TOWN OF PARADISE VALLEY

**Lincoln Plaza Medical Center
Major Special Use Permit Amendment
Work Study Session**

Town Council
December 6, 2018

PLANNING COMMISSION – RIGHT-OF-WAY 10

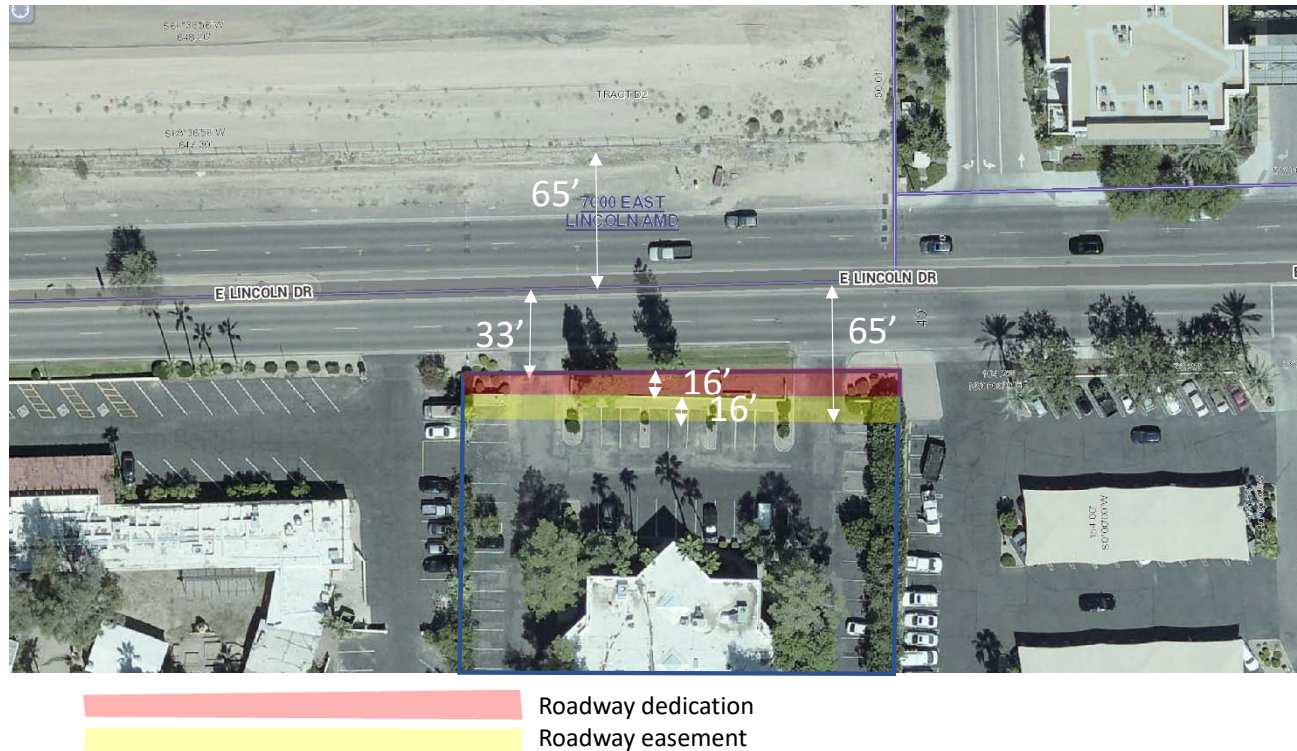
- Existing 33' ROW includes ~ 31' with a portion of the center turn lane, two travel lanes and curb
- 16' additional dedication
- Leaves an additional 18' for sidewalk and 3rd travel lane or deceleration lane within 49' ROW
- Plus 16' roadway easement
- Total south half ROW at 65'
- Total ROW at 130'

GRADE ELEVATION

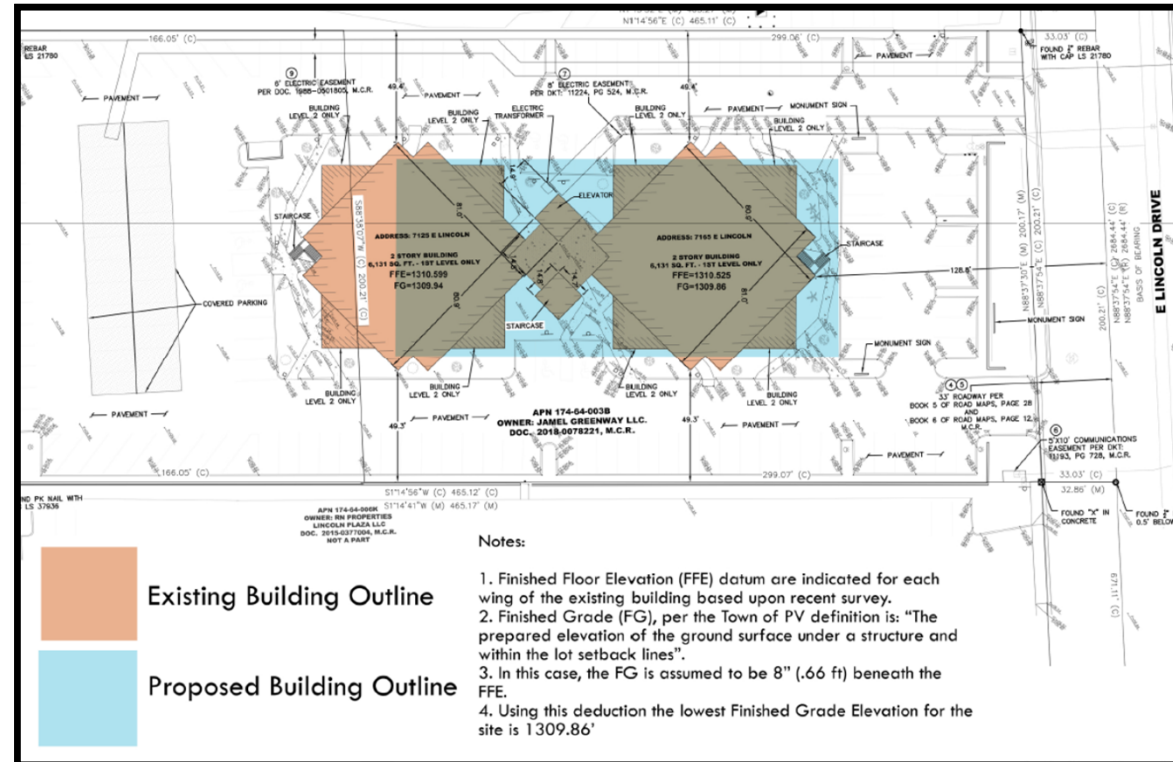
- Applicant lowered height of the building from 36' to 35' from finished floor elevation
- Provided a finished grade elevation exhibit at 1309.86'
- Difference between finished floor and finished grade is 8"
